SIB 52 14 23

THIRD SEAT ROW BACKREST BOWDEN CABLE CHANGE

E-Series	Model Description	Affected Option Code
G07	X7 Sports Activity Vehicle	Vehicles with power third row seat SA4UB

1. Long/old vs Short/new bowden cable

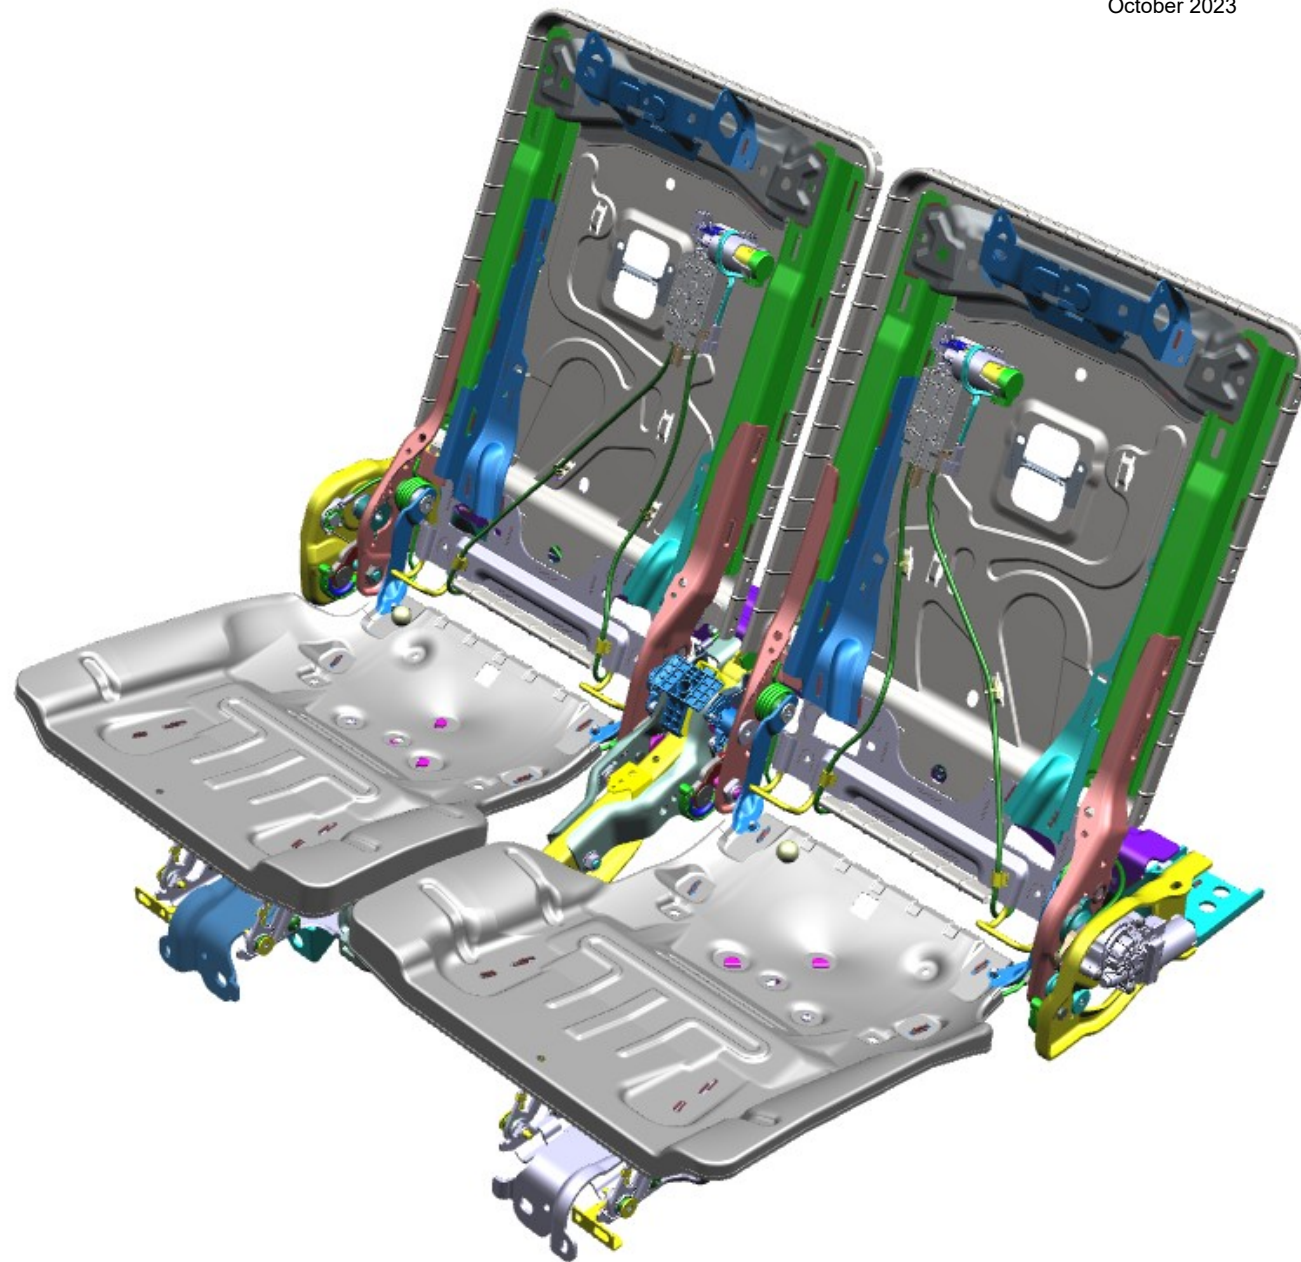
Outboard bowden cable (snowman end)

Old:
Has 2 clipping barrels

New:
Has 1 clipping barrel

Inboard bowden cable (barrel end)

Old:
Has 2 clipping barrels

New:
Has 1 clipping barrel

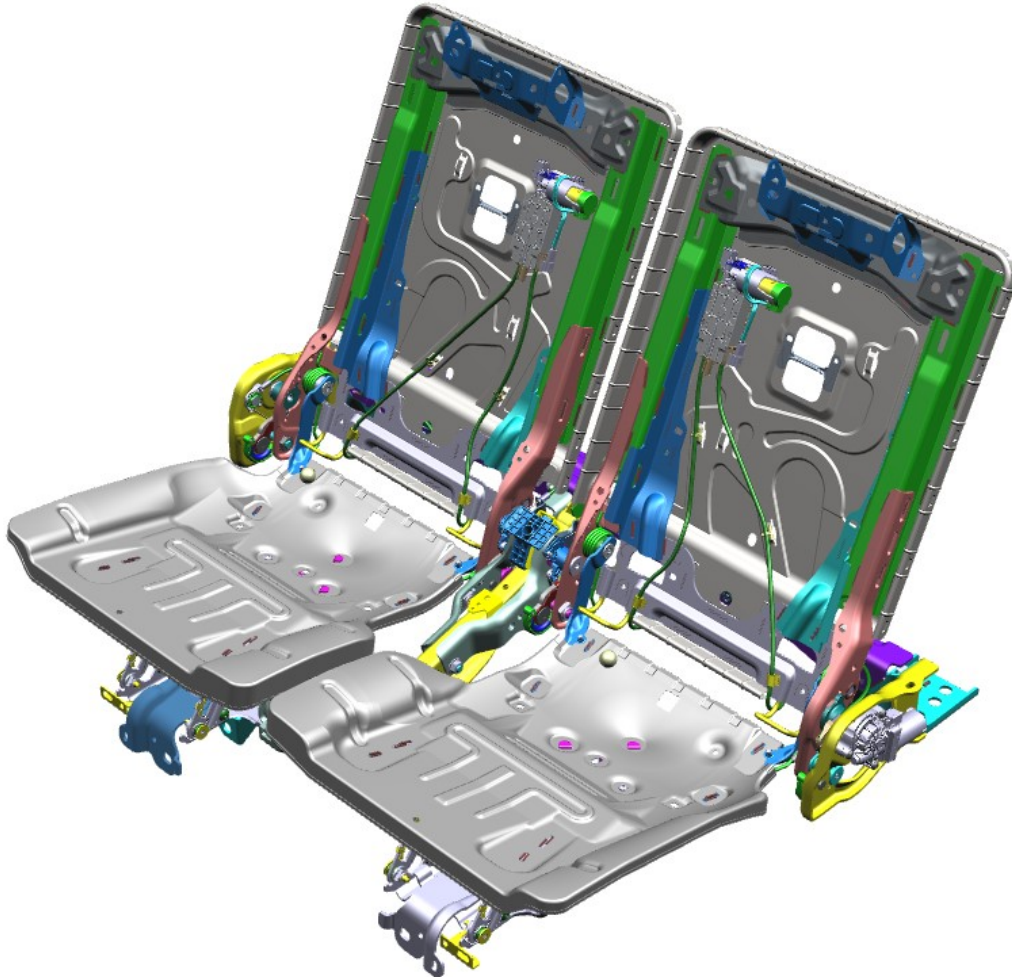
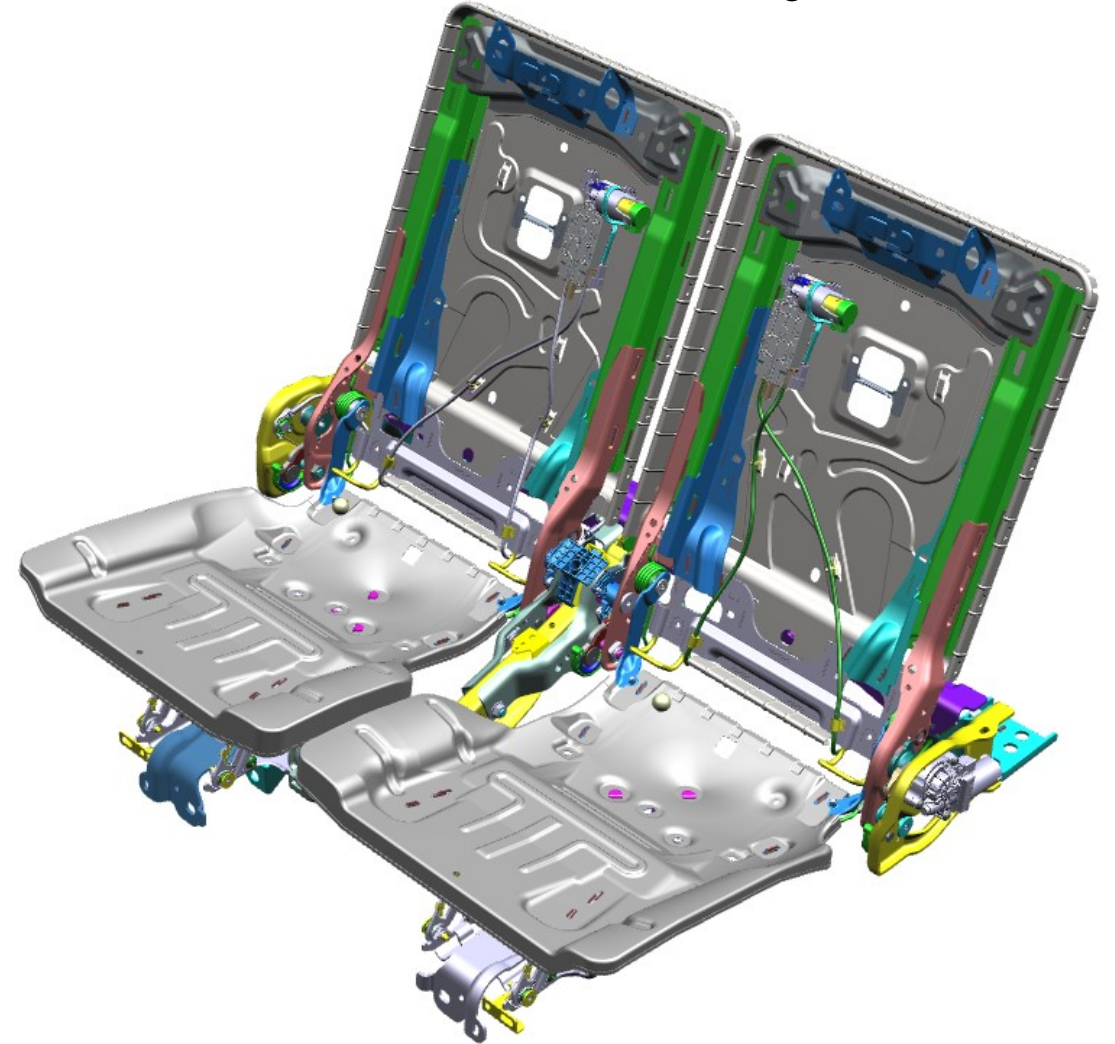
Old bowden cable routing

New bowden cable routing

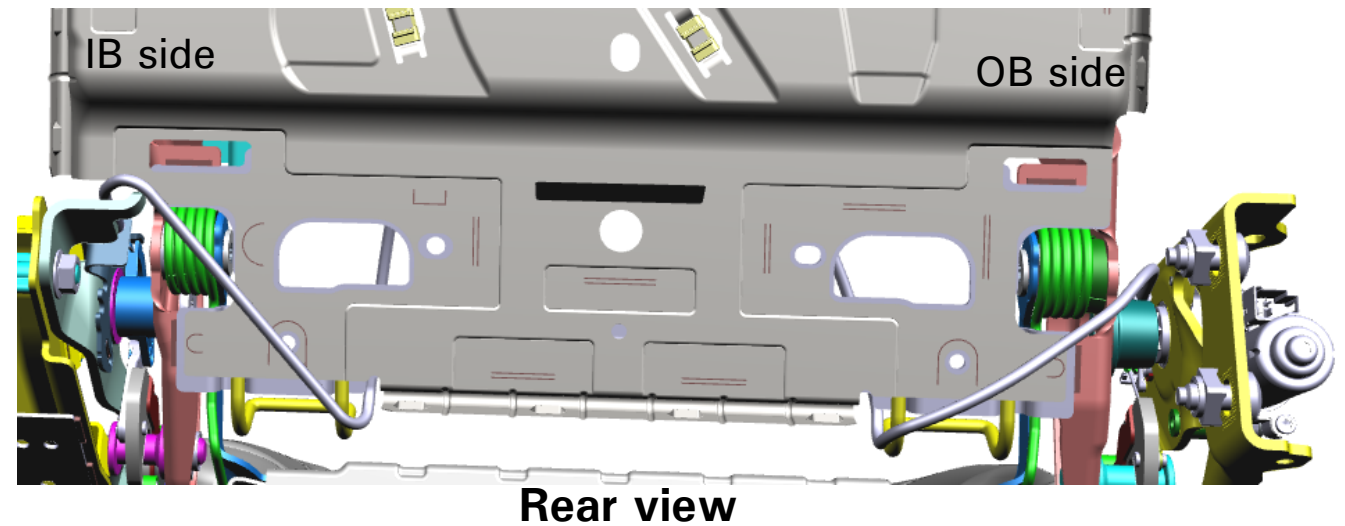
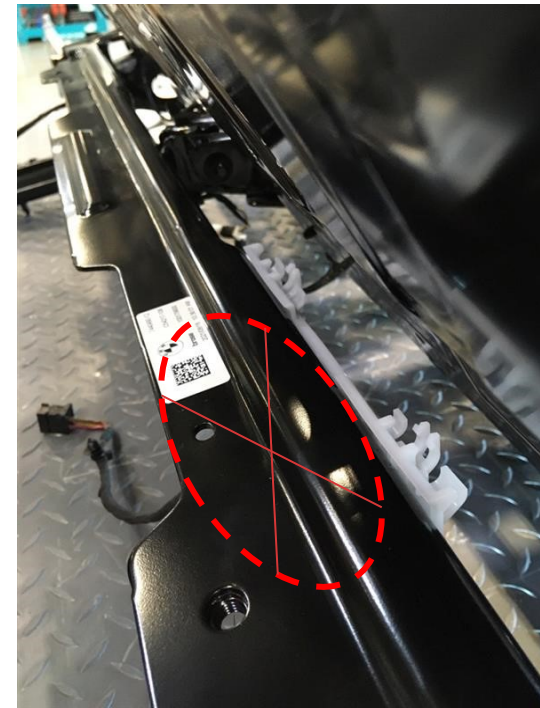
For **new Bowden cable assembly**; routing is not requiring the white fixation clip.

Bowden cable is going under the back panel and on the side of the isofix bracket, like it shows on the image.

Exception for old Bowden cables

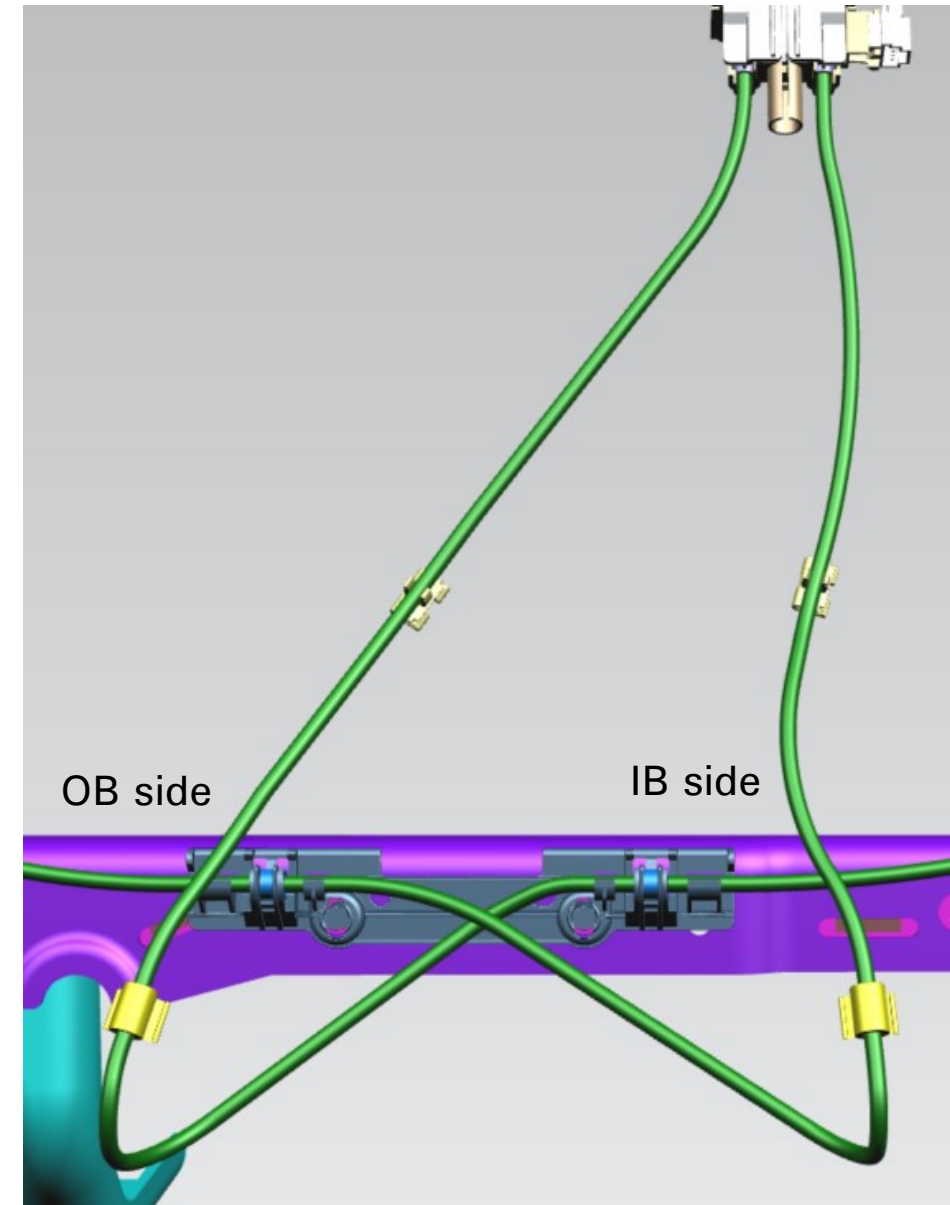
(Before February 2023)

For old Bowden cable assembly; routing should be done throughout the rear traverse, insert the barrel in the white plastic fixation clip.

For OB Bowden cable, it should run from OB to IB throughout the traverse and upwards in the IB side of the backrest.

For IB Bowden cable, it should run from IB to OB throughout the traverse and upwards in the OB side of the backrest.

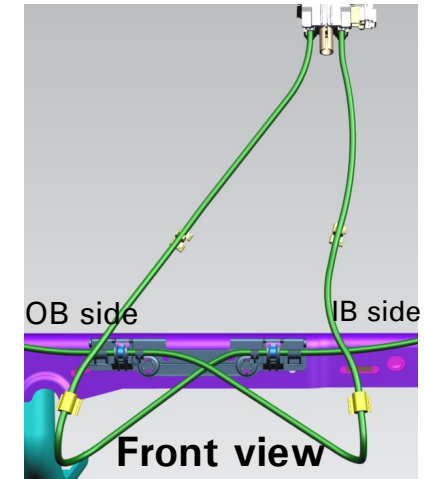
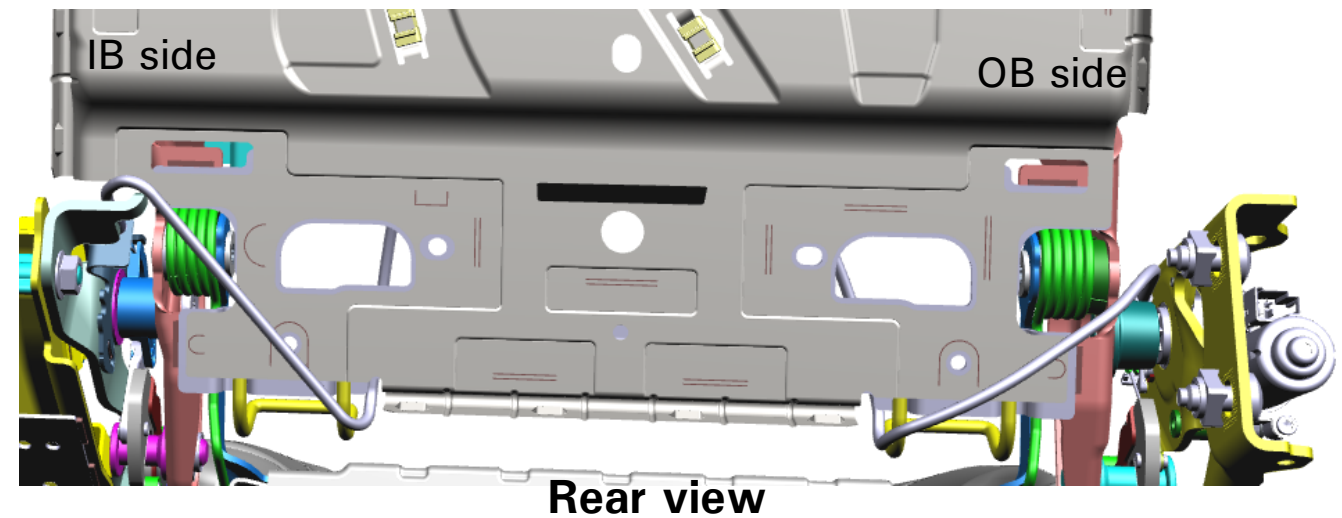
Follow the routing according to the cable used.

Old Bowden cable

New Bowden Cable

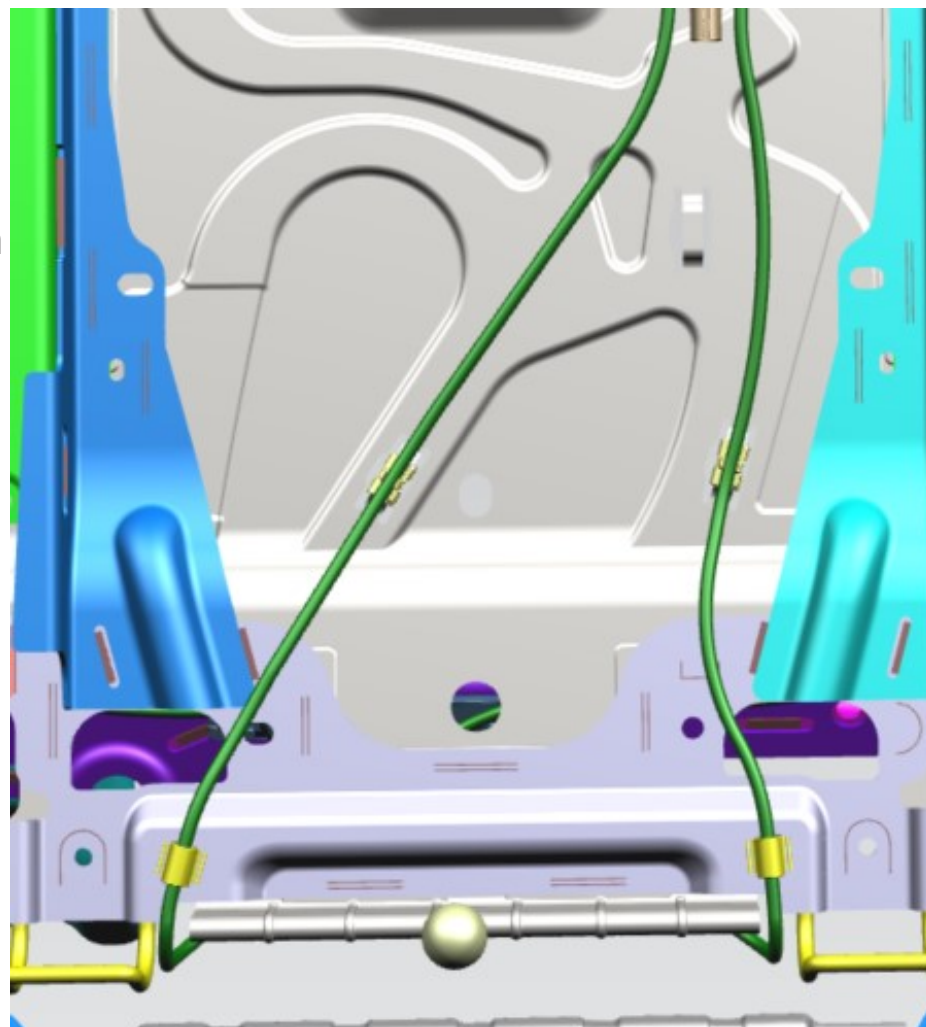
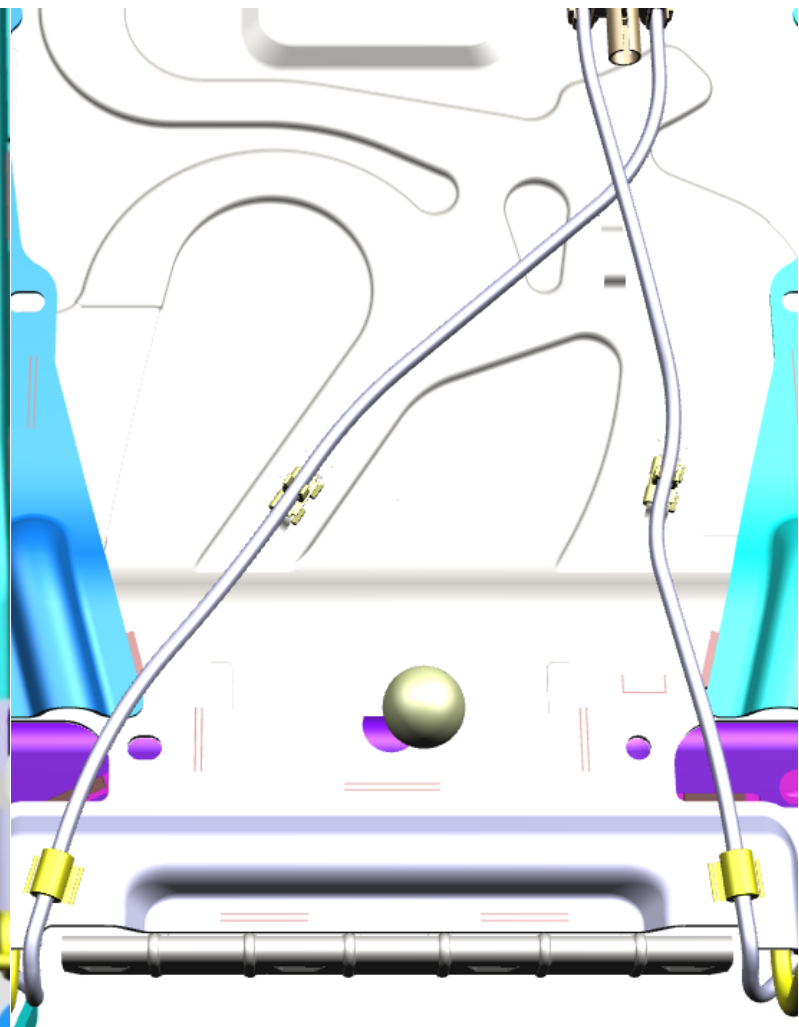
Follow the routing according to the Bowden cable used.

Old Bowden Cable

New Bowden Cable

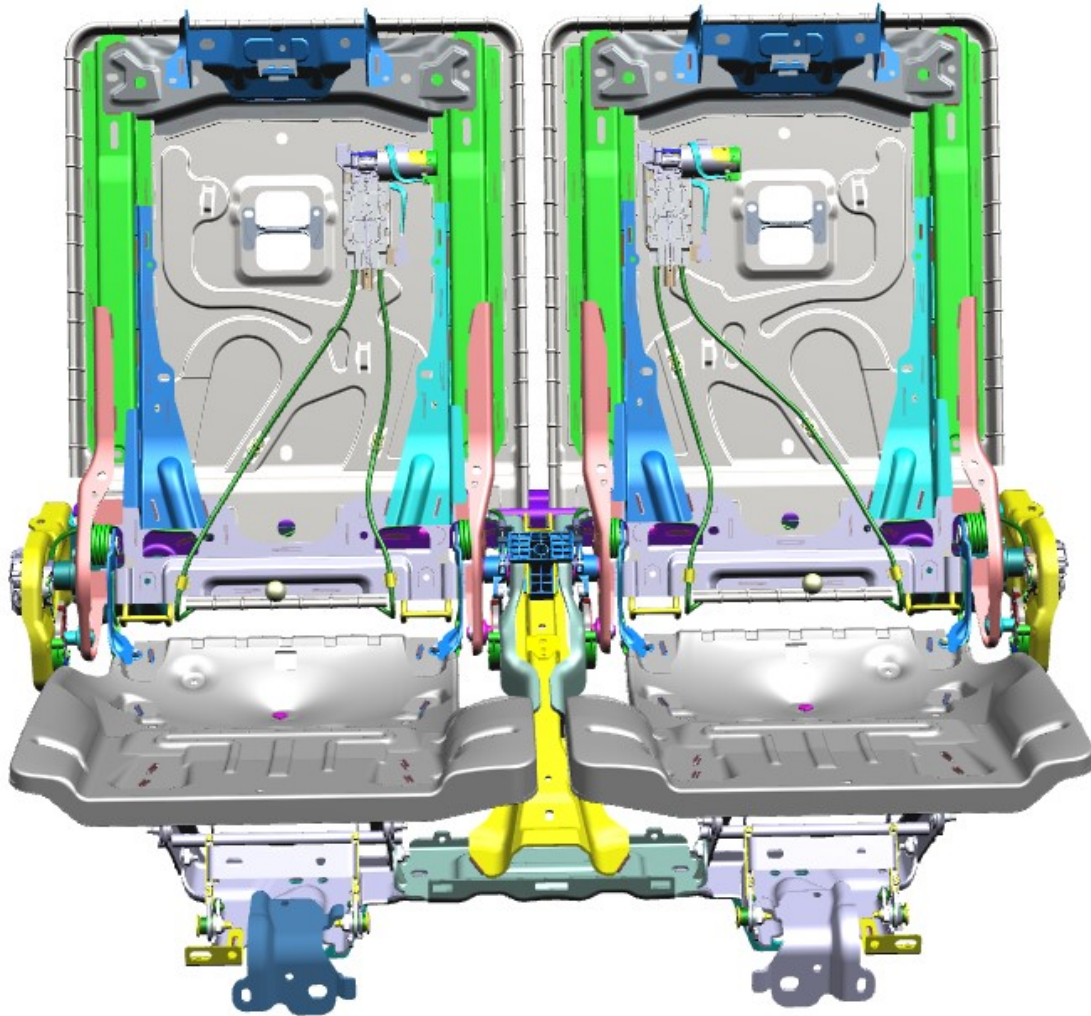
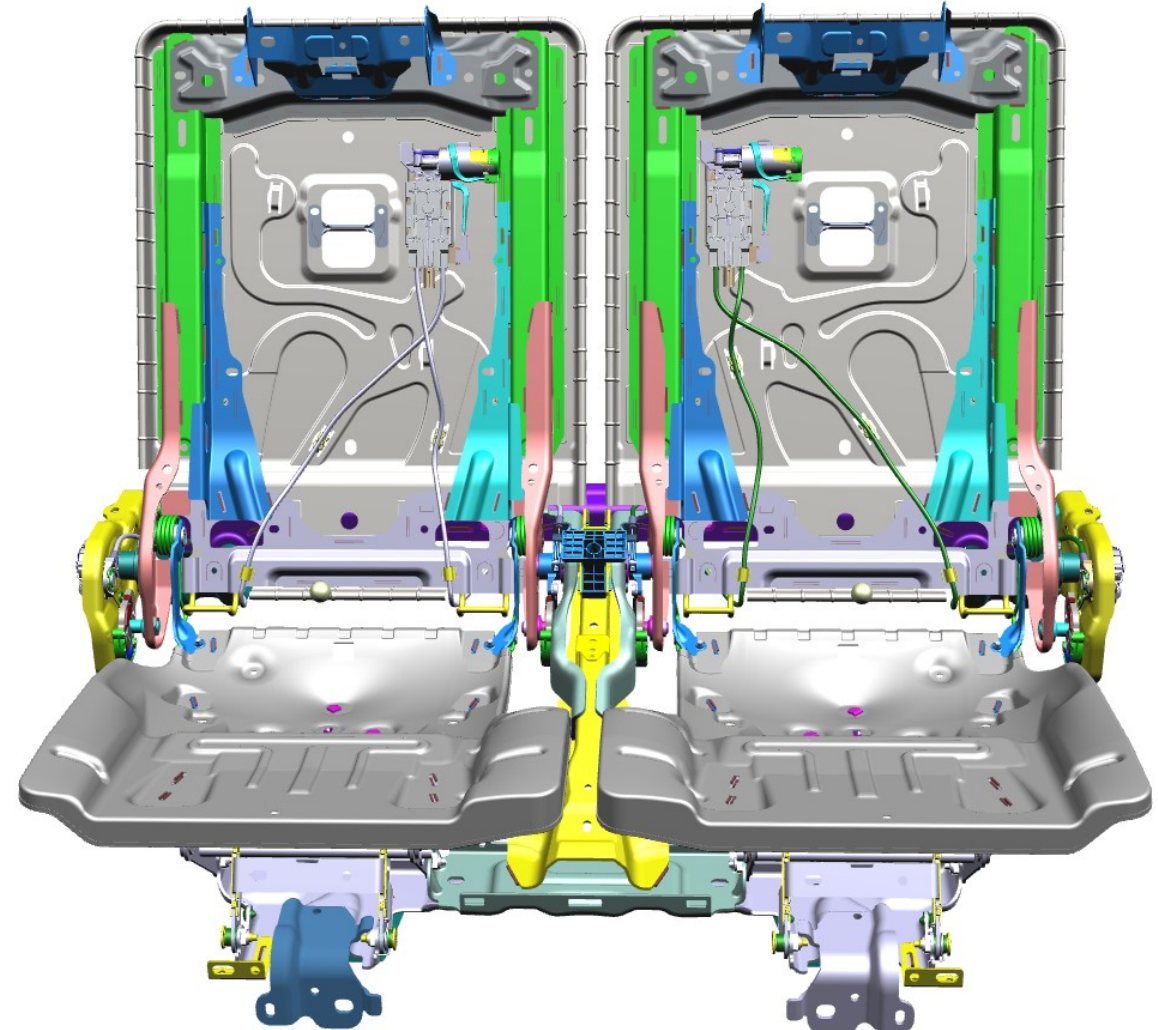
Old Bowden Cable

New Bowden Cable
